CTF3-Note-079

**MINUTES OF FRASCATI MEETING FOR THE TRANSFER LINE
TL1 AND THE COMBINER RING OF CTF3**

This note gives a summary of the meeting held at Frascati on 31st July and 1st August 2006 concerning the CERN/LNF Collaboration for the Transfer Line TL1 and the Combiner Ring of CTF3.

CTF3 - TL1 Line

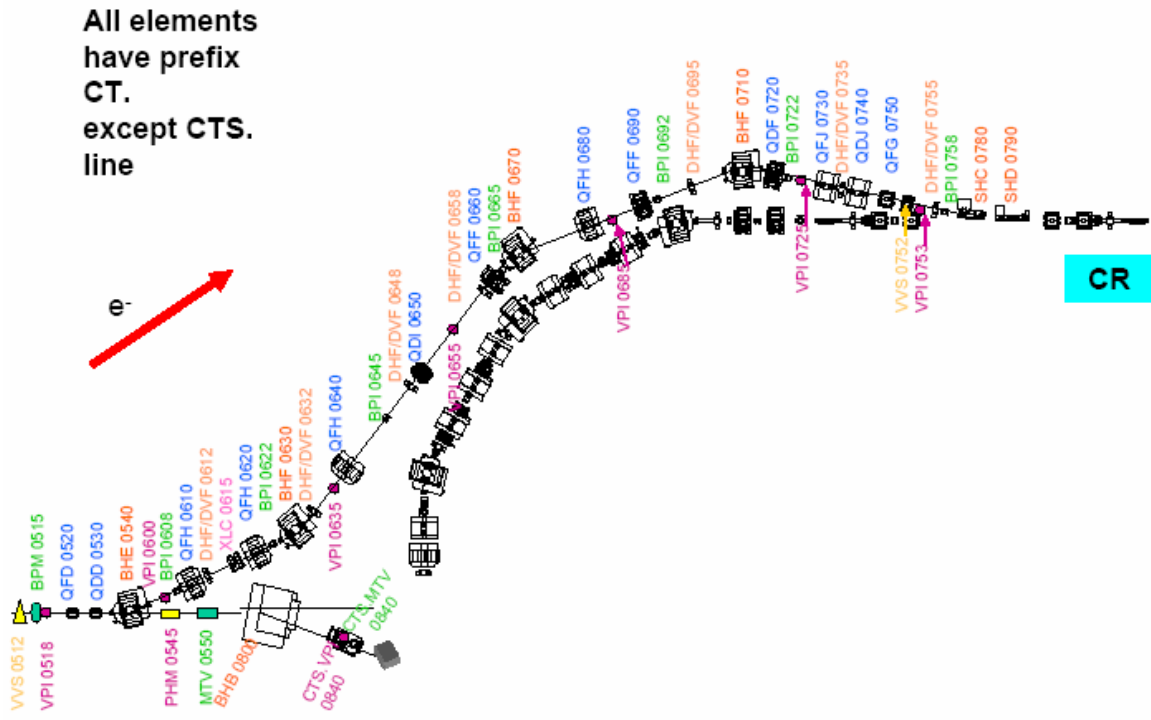
- A problem was discovered in the region of the vacuum chamber inside the bending magnet CT.BHE 0540.

INFN proposes to move the CT.BPR0532 to make space for a new vacuum chamber to avoid a step inside the vacuum chambers after the bending magnet.

Action: choose between 3 solutions:

1. Use special adapter made by Nicolas
2. Move BPR to make room for taper.
3. Make taper inside bending chamber.

- The tapers on each side of the sector valve CT.VVS 0752 in the TL1 line is under the responsibility of CERN. The total length VVS + 2 Tapers = 535 mm.

- INFN will remove two bellows in the straight section of the TL1 line between:

CT.BHE 0540 and CT.VPI 0600

CT.DHF/DVF 0755 and CT.BPI 0758

We choose solution 3. Therefore INFN will make everything including bending chamber. INFN will send the new drawing of the vacuum chamber as soon as possible to Nicolas.
